AIRWORTHINESS DIRECTIVE

TYPE AFFECTED: ASW 24 E

SUBJECT: A) Securing of the engine support bracket screws.
B) Replacement of the lower support bracket of the gas strut near the screw jack.
C) Supplement to the Maintenance Manual.

DOCUMENTATION: ASW 24 E Technical Note No 2.

Fig. 1:

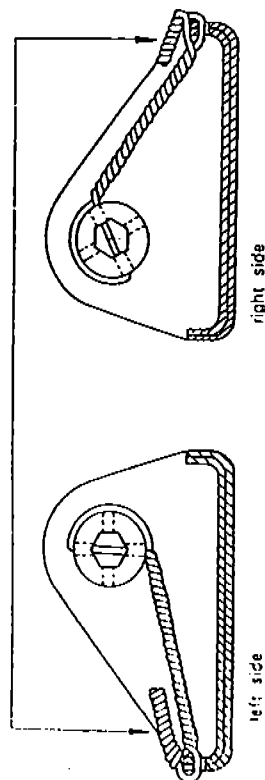
SHEET: 2 of 4	ASW 24 E Technical Note No. 2	Alexander Schleicher Segelflugzeugbau D-6416 Poppenhausen
<u>Reason:</u> Ad A): Some cases with the motorglider ASW 24 E have been reported where the cylindrical screws M10 at the engine support bracket have backed off (see Fig 2.2-5, item 29, on Page 2.11 Maintenance Manual). Ad B): Some cases with the motorglider ASW 24 E have been reported where the cylindrical screw M6 at the lower support bracket of the gas spring near the screw jack has broken (see Fig 2.2-7, item 53, on Page 2.13 Maintenance Manual).		
<u>Action:</u> A-1) If the cylindrical screws M10 at the engine support bracket (see Fig. 2.2-5, item 29 on Page 2.11 Maintenance Manual) have not backed off, they must be secured with a thicker locking wire ϕ 1.4 mm as to be seen in Fig. 1 under point "Material and Drawings". A-2) If the cylindrical head screws M10 are loose or if the locking wire is damaged, in addition also the spacer bushing in the swivelling engine support arm (see Fig. 2.2-7, item 49 on Page 2.13 Maintenance Manual) must be checked for smoothness of operation. If the spacer bushing is seized, its clearance must be re-established by reaming the ϕ 13 mm bore in the swivelling engine support arm larger by ca. 0.05 mm. Where necessary, the bushings must be replaced; in that case proceed as per Action A-1). B-1) Back off the cylindrical screw M10 at the lower support bracket of the screw jack by 1/4 turn (see Fig. 2.2-7, item 98, on Page 2.13 Maintenance Manual) and then carefully grease the lower support of the screw jack. B-2) Remove the lower support bracket of the gas spring (see Fig. 2.2-7, item 54, on Page 2.13 Maintenance Manual) and send it back to SCHLEICHERS for modification of the part. This action is unavoidable because this part was individually adapted to each motorglider. According to Fig. 2 under "Material and Drawings" the modified gas spring support bracket then has to be refitted. Instead of the cylindrical screw M6 now a dowel pin M6 (AS P/N 248.67.00731) is screwed into the housing of the screw jack and is secured with LOCTITE 638 and Activator 764. The bushing for gas spring/screw jack support bracket (see Fig. 2.2-7, item 55 "Drehteil f. Gasfeder/Ausfahrspindel unten", on Page 2.13 Maintenance Manual) is no longer applicable.

Ad A) Locking wire $\phi 1.4$ mm, ≈ 1 m and possibly spacer bushing for swivelling engine support arm (AS P/N 248.67.0009).

Secure the locking wire ends by 6 turns minimum !

Fig. 2:

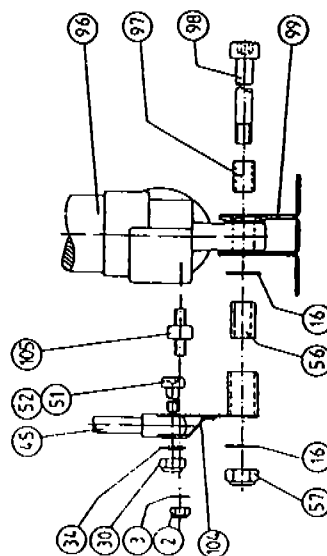
Ad B) Lower support bracket for gas spring, variant II (AS P/N 248.67.0072) and Dowel pin M6 for screw jack (AS P/N 248.67.0073).

Front view
Ansicht von vorn !
